The Commission has issued the enclosed Amendment No. 17 to Provisional Operating License No. DPR-16 for the Oyster Creek Nuclear Generating Station. This amendment consists of changes to the Technical Specifications and is in response to your application dated May 20, 1976.

OYSTER CREEK NUCLEAR GENERATING STATION, UNIT NO. 1

Amendment No. 17
License No. DPR-16

ATTACHMENT TO LICENSE AMENDMENT NO. 17
TO THE TECHNICAL SPECIFICATIONS
PROVISIONAL OPERATING LICENSE NO. DPR-16
DOCKET NO. 50-219

FIGURE 6.2.1
 OYSTER CREEK STATION
 MANAGEMENT ORGANIZATION CHART

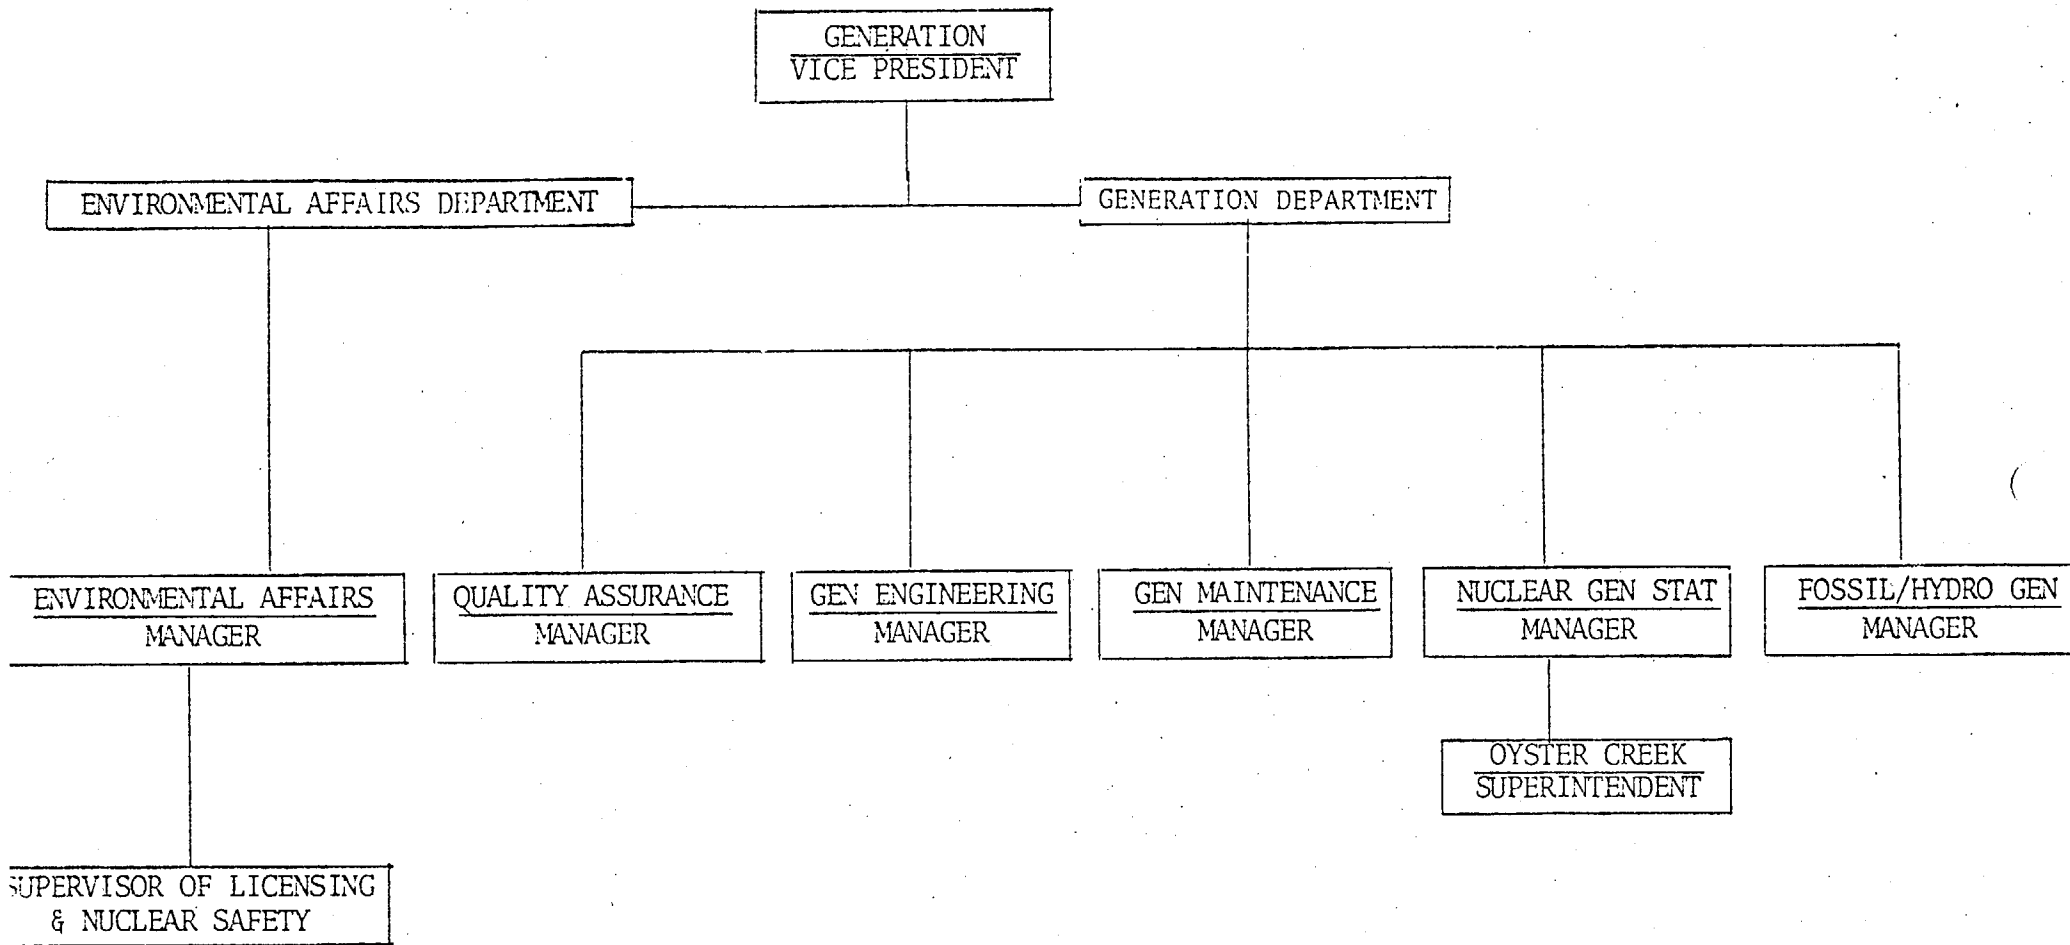
Replace pages 6-3 and 6-5 through 6-9 with the attached revised pages.
